Ariyan Socks Industries Ltd

Mawna, Tengra , Sreepur, Gazipur, Bangladesh
(24.23112N,90.45715E)
29th March 2022

Building Information

Proposed elevation of 4 storied

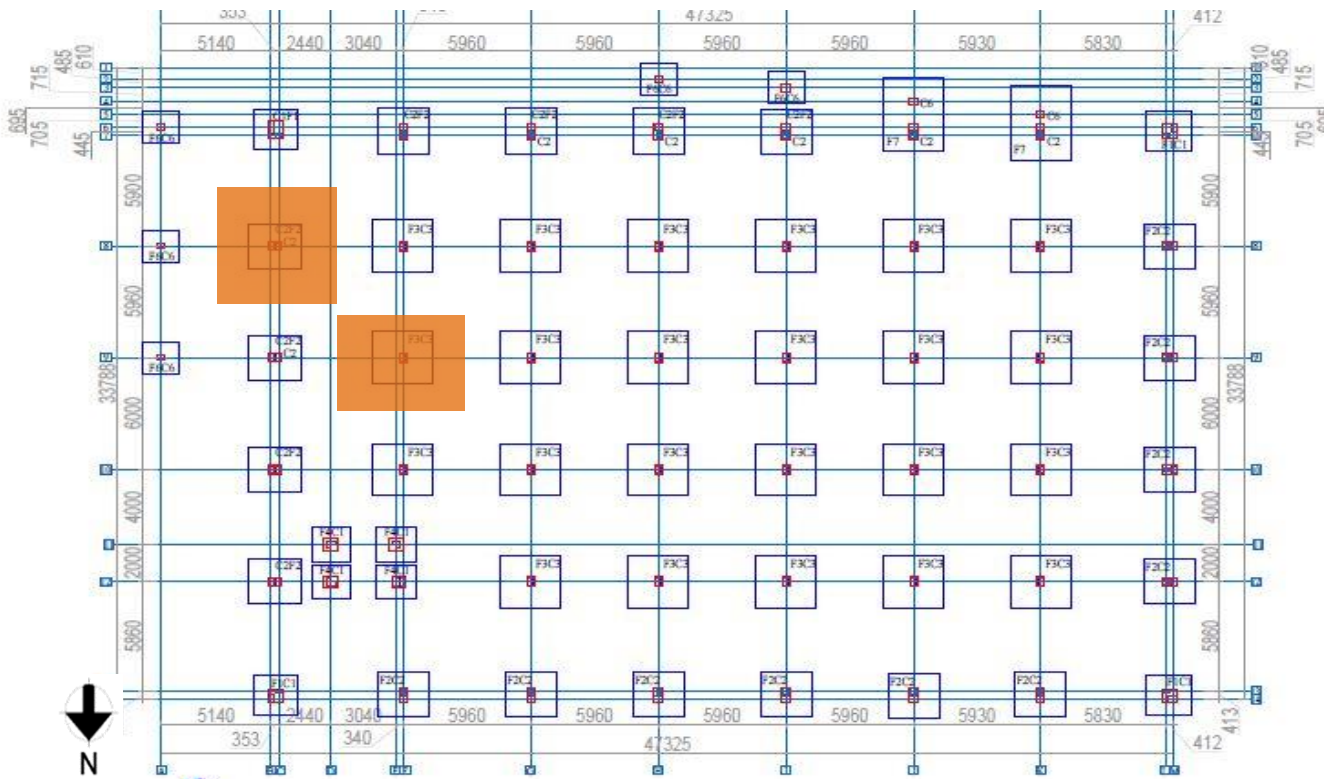
**Ongoing vertical extension works required to
be ceased immediately**

The factory has a plan to construct the building up to 4-storied.

Building is currently 2 storied

Ongoing construction on 2nd floor

Column/footing layout

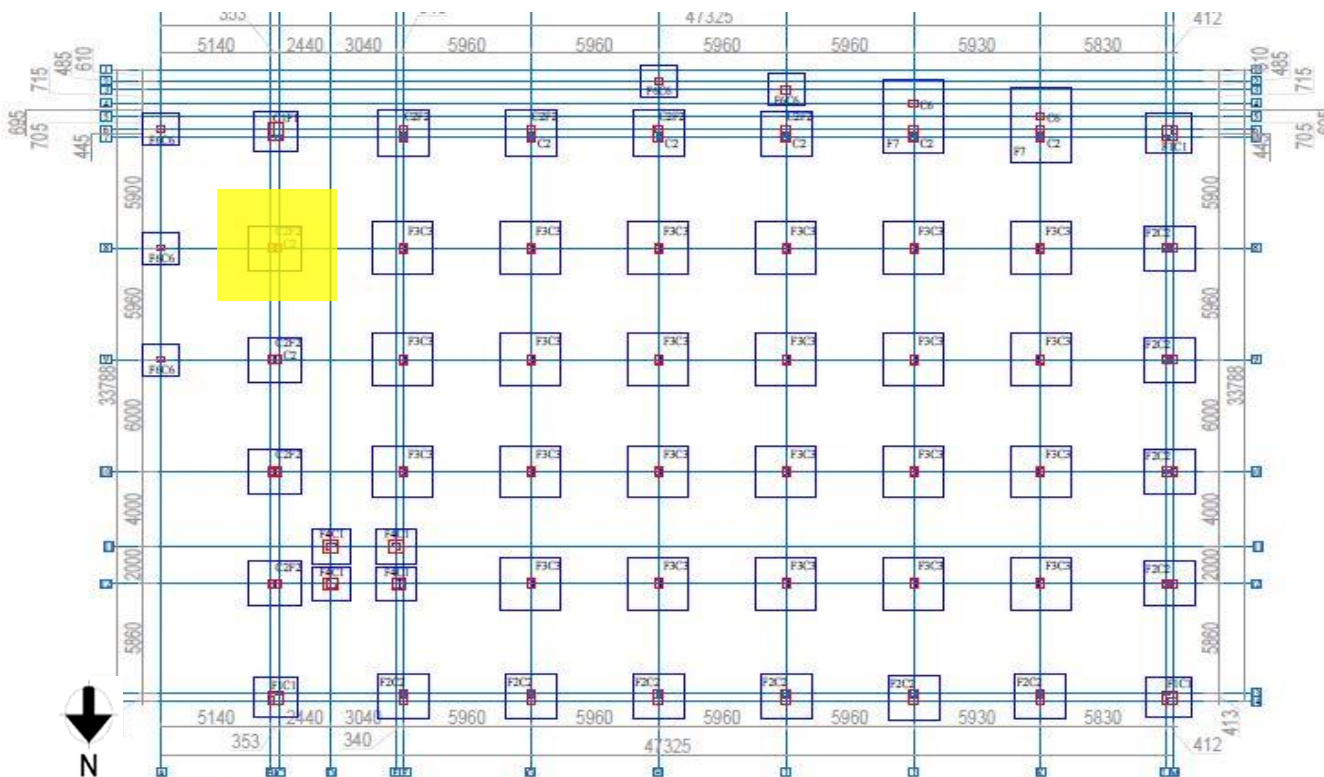
Cursory calculation indicates the high stress level in highlighted columns (marked in the layout) for above of 2 storied building. Factory is required to cease all kind of extension work immediately. Factory engineer is required to review, design of column stress and prepare a Detail Engineering Assessment (DEA) report prior conducting any vertical extension.

Cursory calculation indicates that stress in foundation exceeds normal design limit in highlighted foundation (marked in the layout) for above of 2 storied. Factory engineer is required to review, design of foundation stress and prepare a Detail Engineering Assessment (DEA) report prior conducting any vertical extension.

Absence of design documents

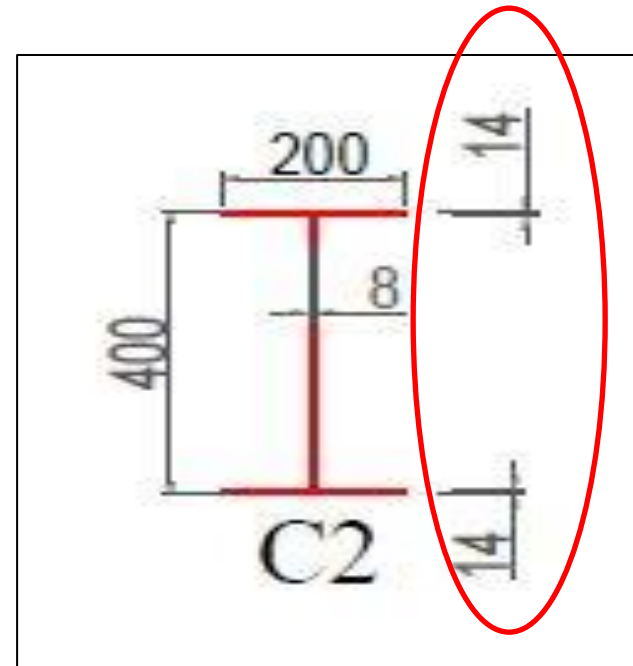
As per BNBC, every building or structure designed shall have its design documents prepared in accordance with the provision of Section 1.9.1. The design document shall include a design report, and a set of structural drawings, which shall be prepared in compliance with section 1.9.1.1 and section 1.9.1.2 as per BNBC. At the time of inspection, design report was not available which is required to be prepared in compliance with section 1.9.1.1 (part-6, BNBC).

Discrepancy and missing information in as-built drawing

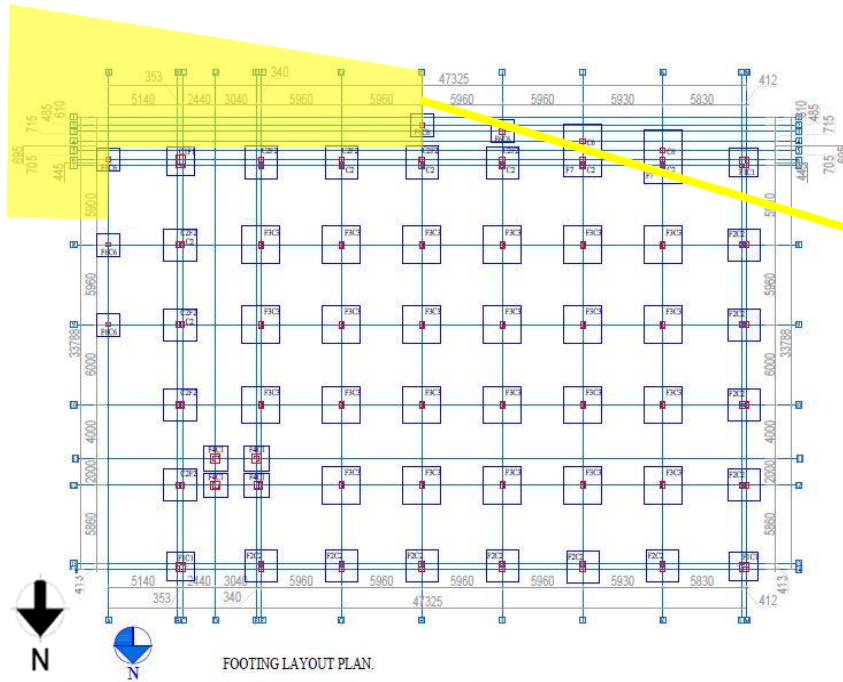
Flange thickness of column C-2 was measured as 10mm at ground floor

Flange thickness of column C-2 shown as 14mm

Flange thickness of column C-2 was measured as 10mm but shown in drawing as 14mm. Due to the change, the FoS of the columns significantly changes at ground floor level. Factory engineer is required to resurvey the whole structure and update as-built drawing accordingly.

All internal steel columns are enclosed by RC casting

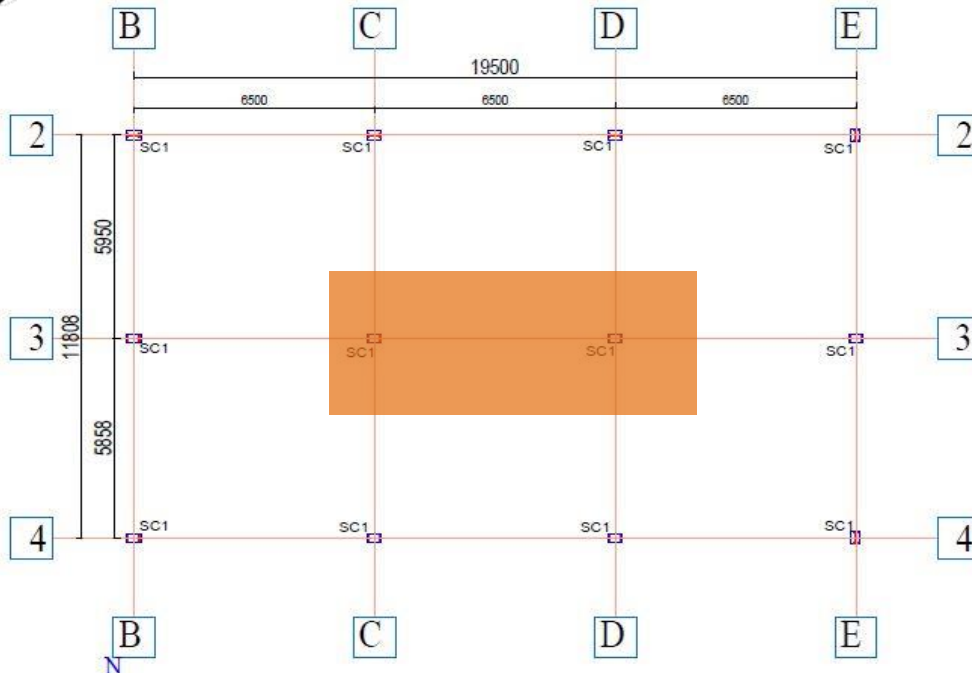
All internal steel columns were found enclosed by RC casting therefore the dimension/thickness of internal steel columns couldn't be verified. Factory engineer is required to confirm the dimension/thickness of all internal steel columns.

Lack of lateral stability

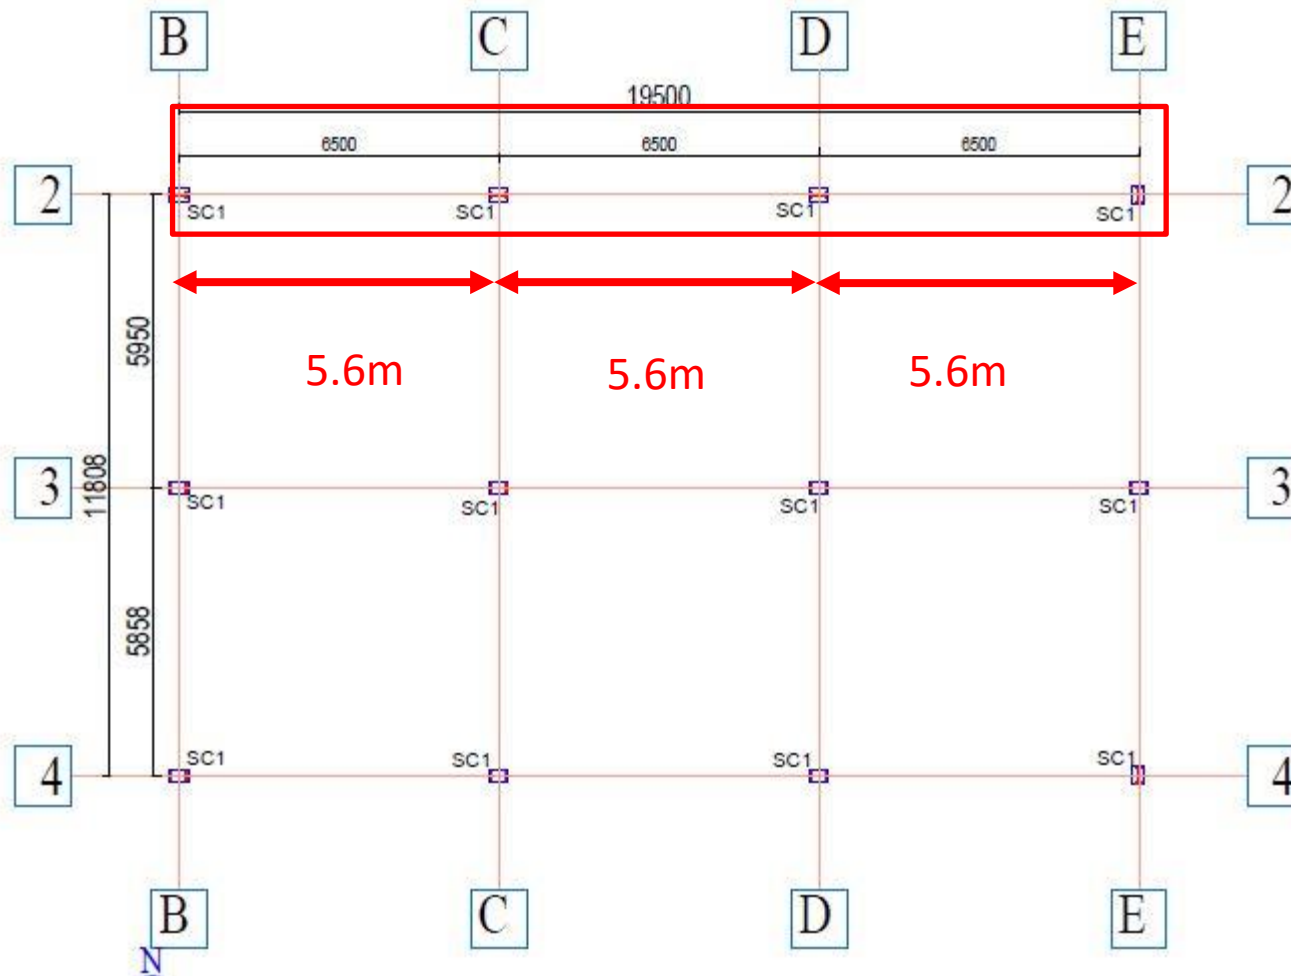
Moment resisting frame is only provided along long direction

No wall bracing is provided

Moment resisting frame is only provided along long direction and no wall bracing is provided therefore there is apparently lack of lateral stability along short direction. Factory engineer is required to check the lateral stability of the structure.
